THE GRANGE AT LINDEN DESIGN REVIEW BOARD

12.05.2016

DPD PROJECT # 3020289

DESCRIPTION:
7 STORY ASSISTED LIVING RESIDENTIAL FACILITY
109 UNITS, 114 BEDS
46 PARKING STALLS

TYPICAL RESIDENTIAL LEVEL AT EDG 2

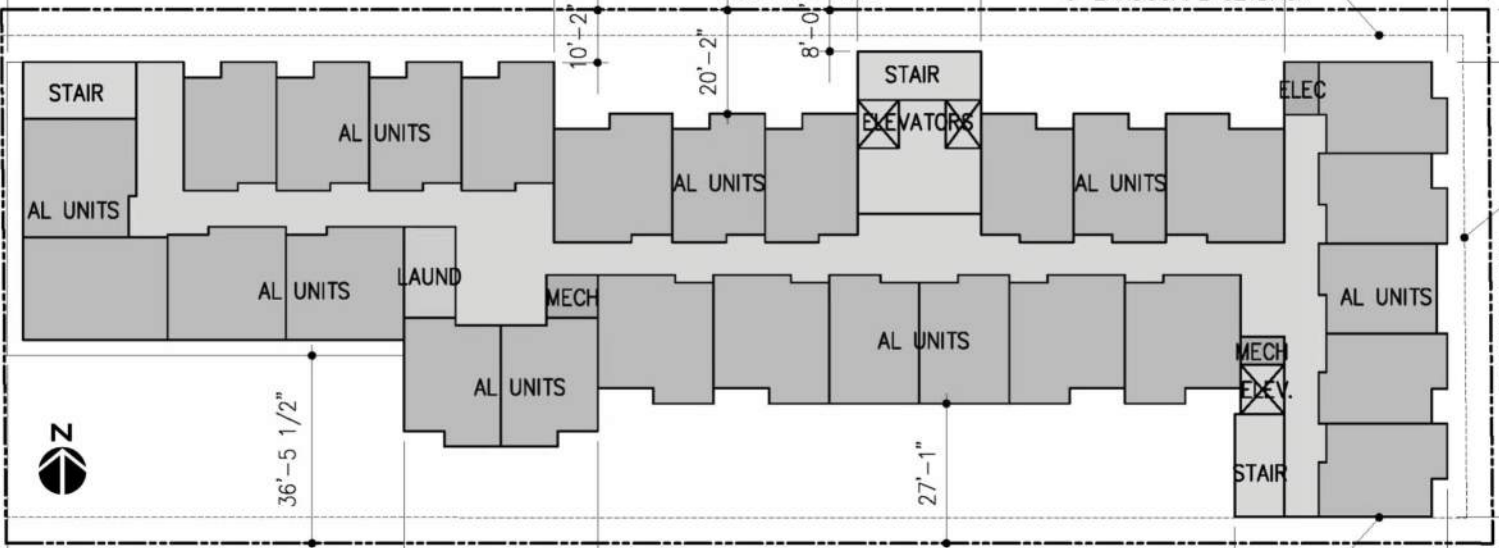
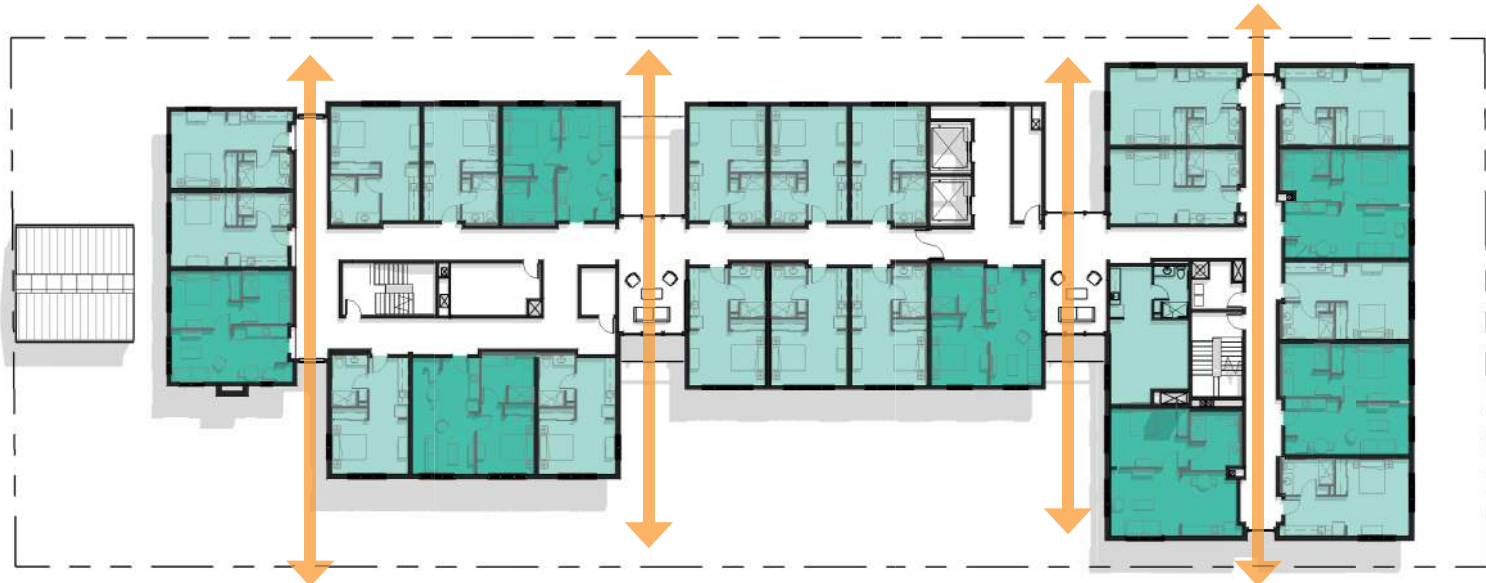
"The modulation and materiality of the upper levels should be simplified and more purposeful. (DC2-A-1&2, DC2-B-1, DC2-E-1, DC4-A-1)"

- Too much modulation
- Long Corridors, no light
- No relation between exterior modulation and building function

The building massing has been revised to be more purposeful. The units have been grouped into residential pods and pulled apart to allow light in and views out along the long floor plate. This purposeful modulation lets light in while breaking down the exterior massing. The revised configuration provides simplified and elegant building modulation.

- Simplified modulation
- Stairs moved away from exterior to allow residents more access to light and views out
- Eliminate long corridors without natural light
- Light filed common areas on each floor
- Strong relationship between building massing and building function

PROPOSED DESIGN AT EDG II

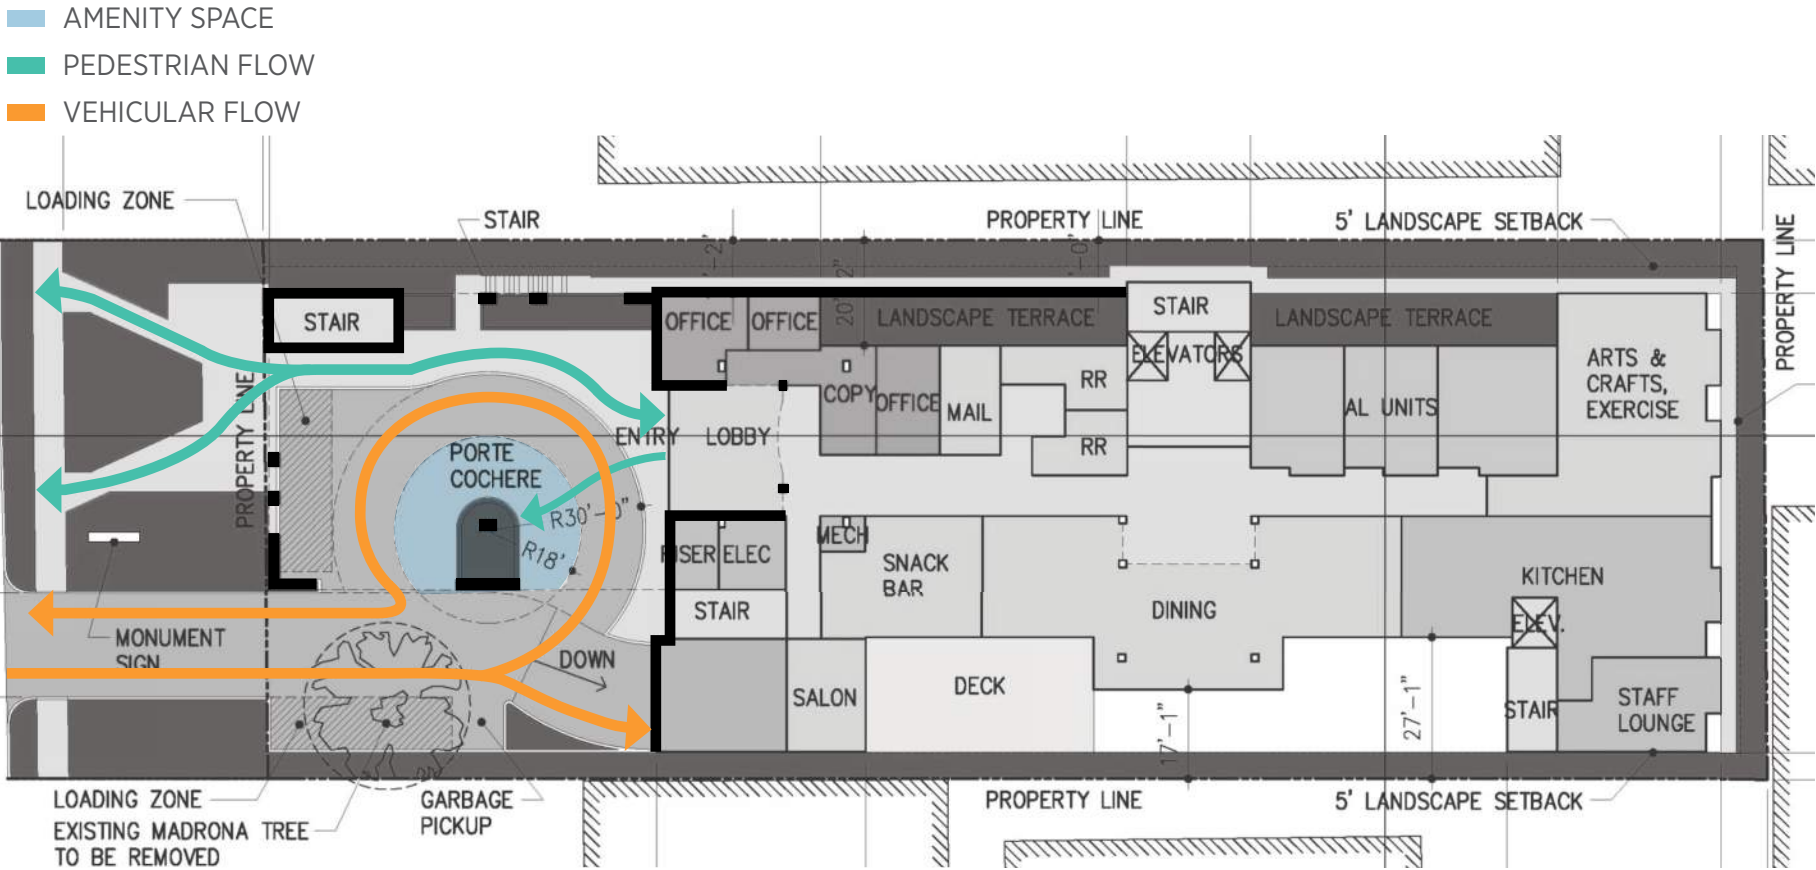
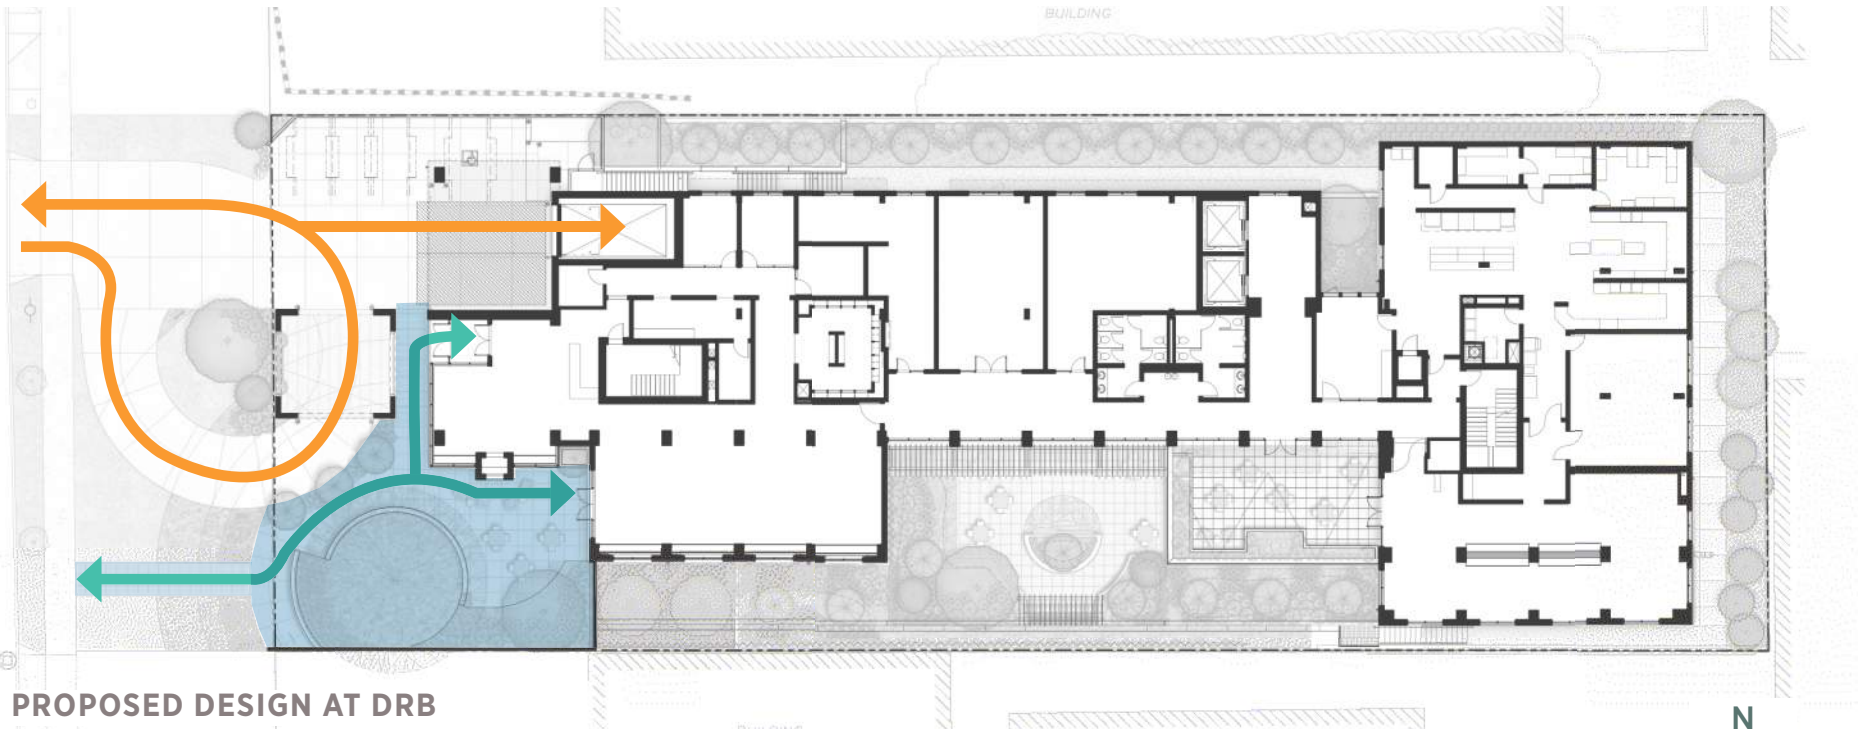
"The area (under the porte cochere) should be further developed to demonstrate how it will function as a safe, successful pedestrian oriented entry and partially enclosed amenity space. (DC3-A, DC3-B-all, DC3-C-2, DC4-C&D)"

- "The space should include quality, human scale elements including high-quality paving materials, landscaping, lighting, signage, and seating.
- "The entry should have a stronger connection to the street. For recommendation, the applicant should provide additional information on the pedestrian and bicycle entry sequence."

- Building facade and garage entrance provide no human scaled elements.
- Facade is not welcoming.
- Building proportions are neither residential nor commercial.
- Common areas within building are not visible from sidewalk.

At EDG the porte cochere was designed as an enclosed space behind the main facade with an integrated amenity area. The entry has been reconfigured to:

- Fully separate pedestrian and vehicular access
- Position outdoor amenity area in direct proximity to indoor amenity area

- The entire porte cochere has been redesigned as a smaller more human-scaled element.
- An outdoor fireplace and gathering area has been added.
- Pedestrians have a dedicated pathway from the lobby and the amenity area directly to the street.
- On site bike parking has access to both the paved driveway and the pedestrian.

PROPOSED DESIGN AT EDG II

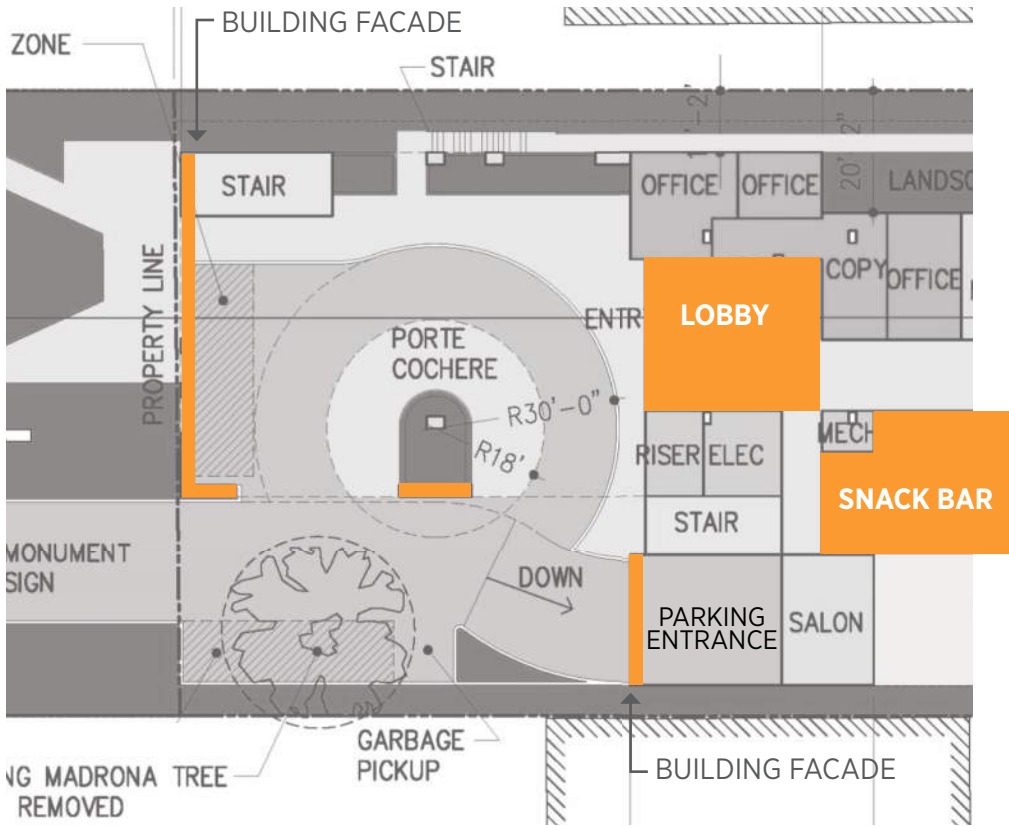
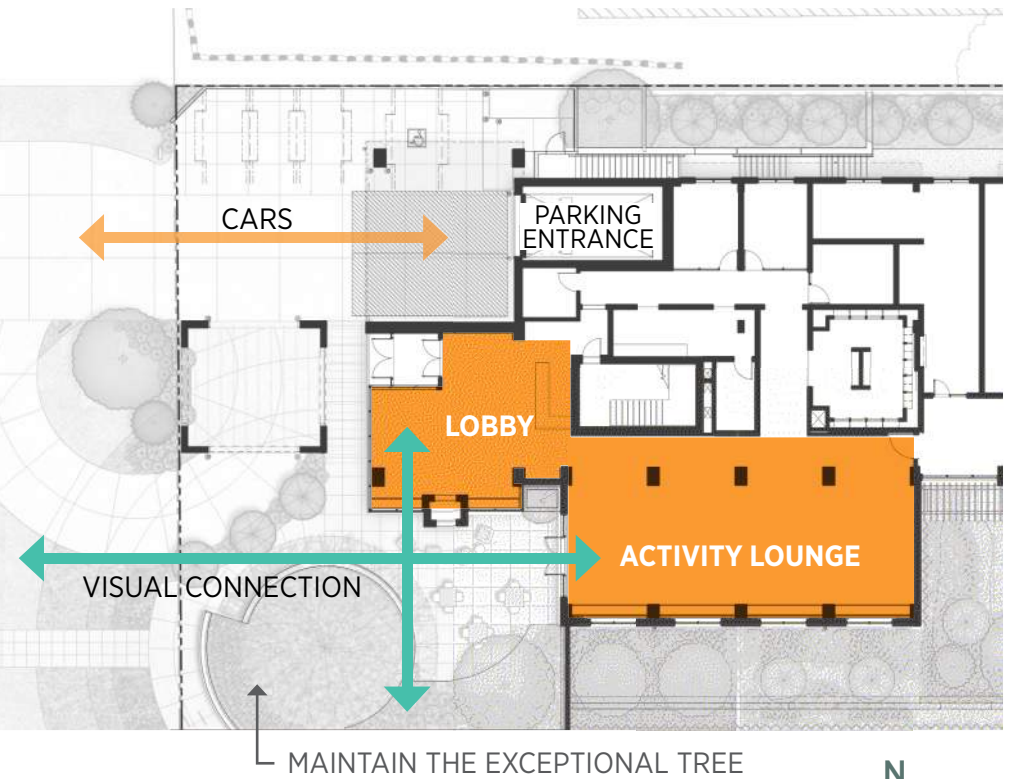
"In general, the (front of the buiding) could be more open and should have a stronger indoor/outdoor relationship. If glass is proposed, operable windows (i.e. roll up or accordion glass walls) should be considered."

- Amenity areas have no direct relationship or views to outdoor areas.
 - Southwestern edge of site given over to vehicular circulation.
 - Building facade is used to screen vehicular traffic and loading, not residential function.
-
- All major common areas are connected to outdoor amenity space.
 - Common areas are now visible to the street, to help activate pedestrian experience.

In the EDG plan, all parts of the street-facing facade are backed by vehicular use. In the proposed plan, vehicular access is minimized and direct visual connection to public functions of the building is prioritized. Indoor amenities are put in direct proximity to outdoor amenities to reinforce the indoor/outdoor connection.

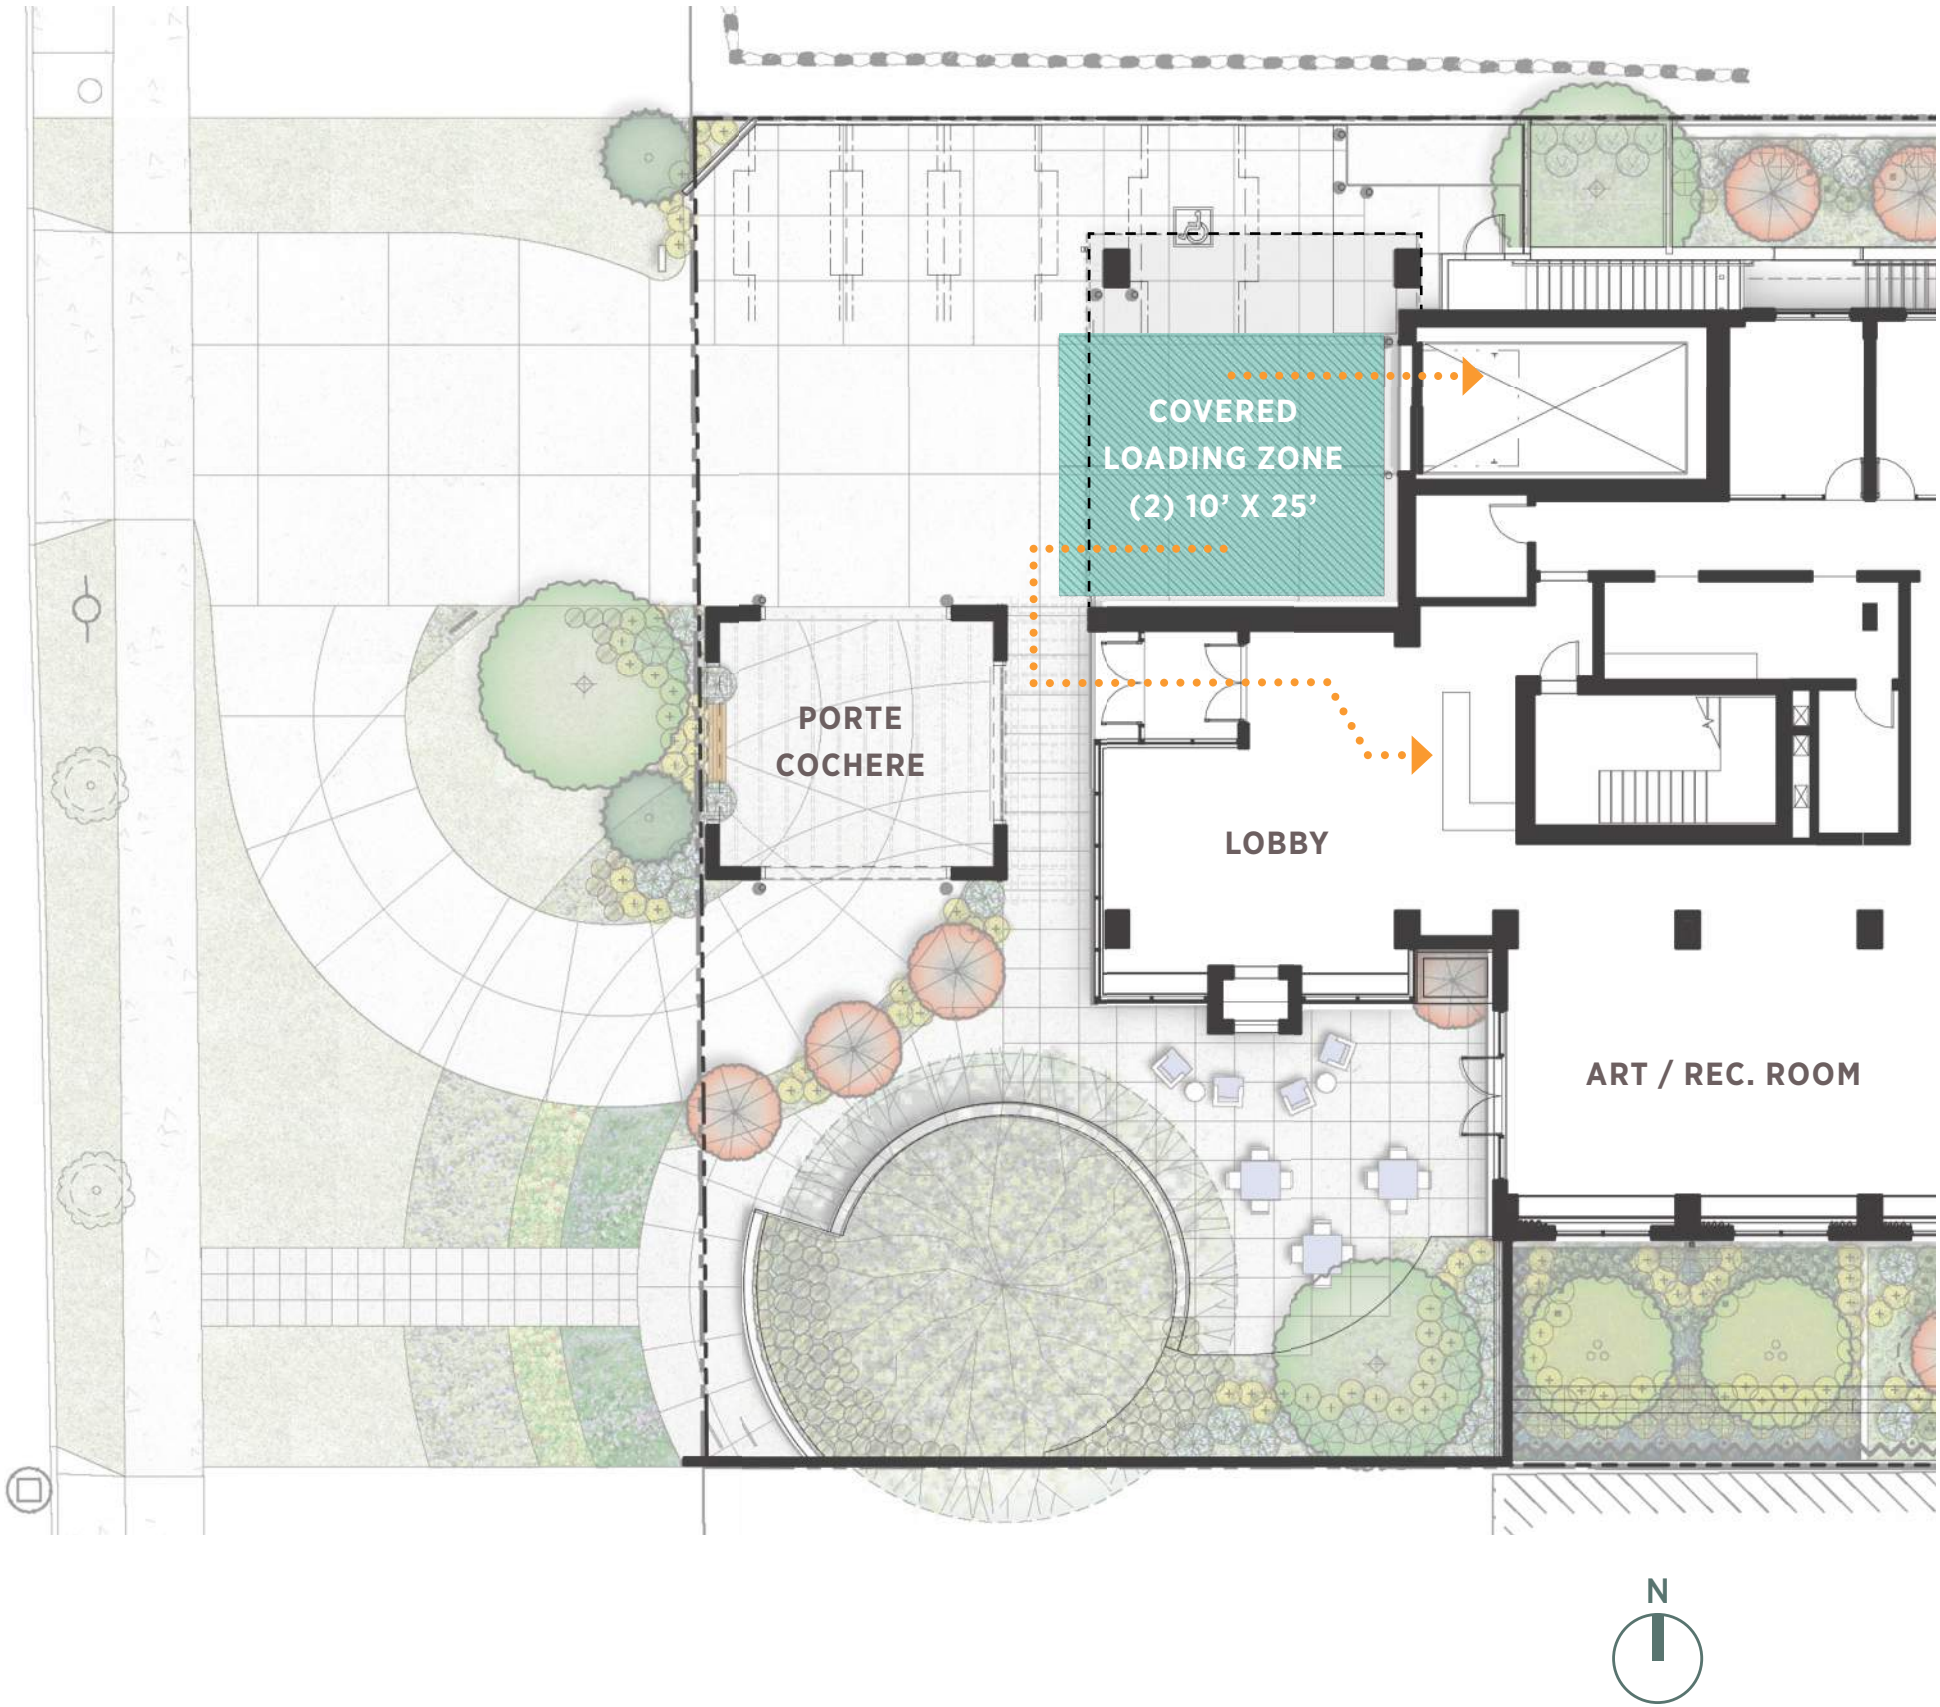
"The Board expressed concern with the porte cochère area as a loading zone and deliveries proposed through the front entry and lobby. Alternative loading and delivery options should be considered to minimize their impact on the entry and drop-off area. For the next meeting, the applicant should provide additional detail (including staging and routes) for loading and deliveries. (DC1-C-4, PL3-A-1, PL3-A-4)"

The loading zone has been removed from the porte cochere drop off area. Small deliveries such as mail and packages for residents can be brought through the lobby to the front desk. Larger deliveries will be taken down through the car lift to the basement level and distributed from there.

We are seeking one departure regarding the loading zone. Please see page 64.
